Staff Summary Report

SUBJECT: Hold a public meeting for a Development Plan Review for MIDFIRST BANK, located at 8775 S. Priest Drive.

DPR08074 – Development Plan Review including site plan, building elevations, and landscape plan.

SITE PLAN EXHIBIT
A101

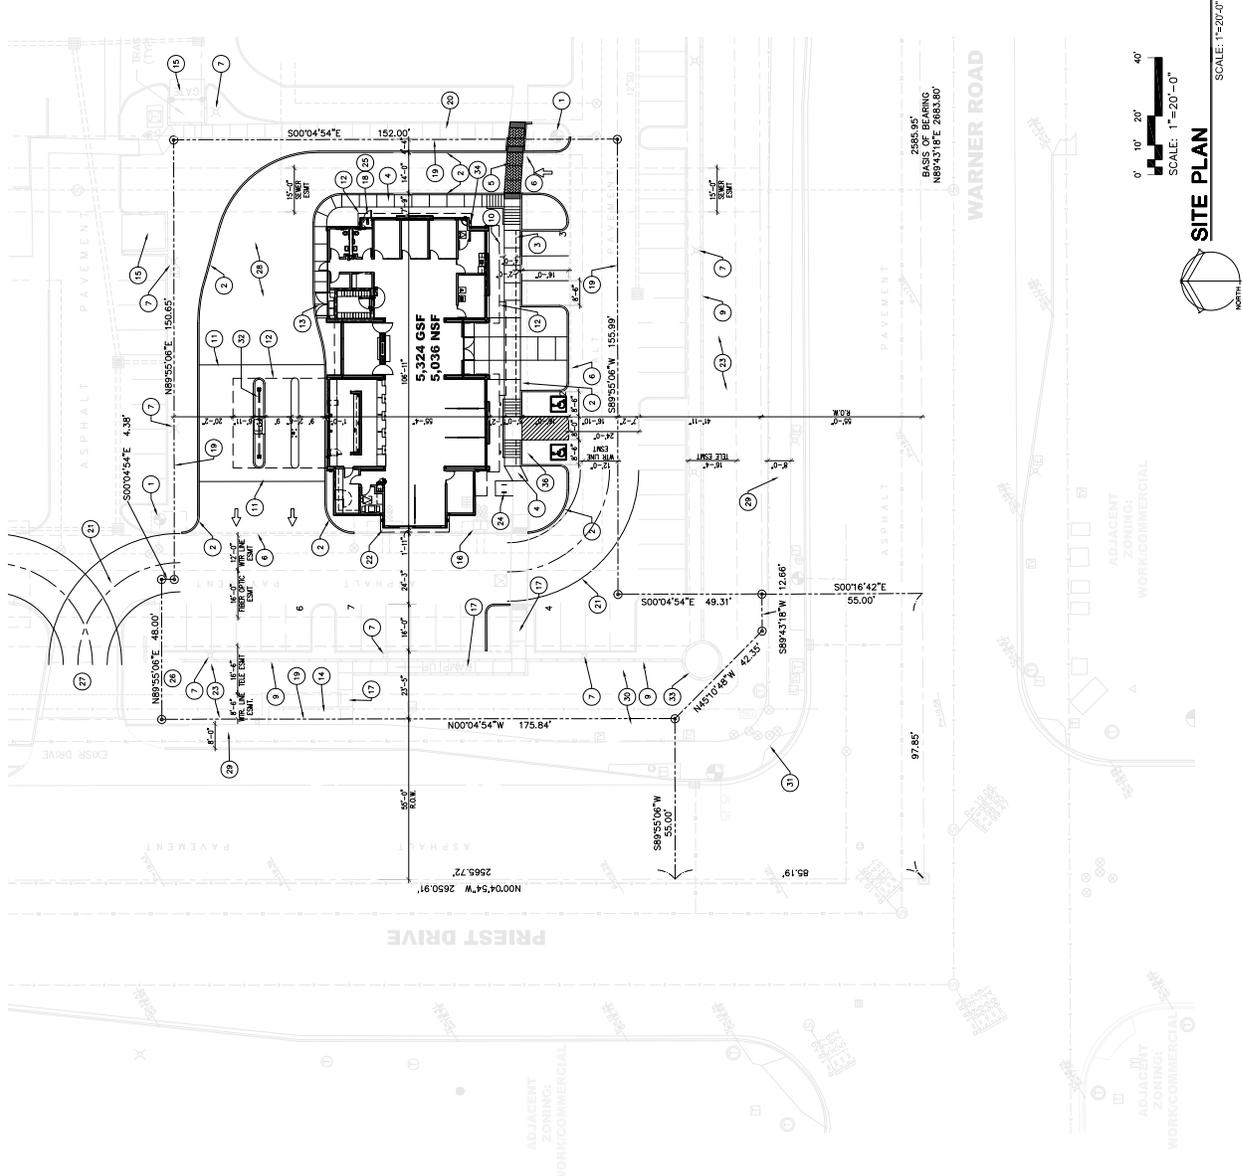
1. Provide service yard and mechanical yard walls that are at least 8'-0" tall as measured from adjacent grade and are at least the height of the equipment being enclosed, whichever is greater. Verify height of equipment and mounting base to ensure that wall height is adequate to fully screen the equipment. Locate electrical service entrance sections inside the service yard, as indicated.

- **WATER:** Revise site plan and floor plans to recess the pop-out on the western side of building, reducing it by 8' to provide a total of 16' separation from the existing water line; or resolve this conflict with Water Utilities Department prior to building permits.
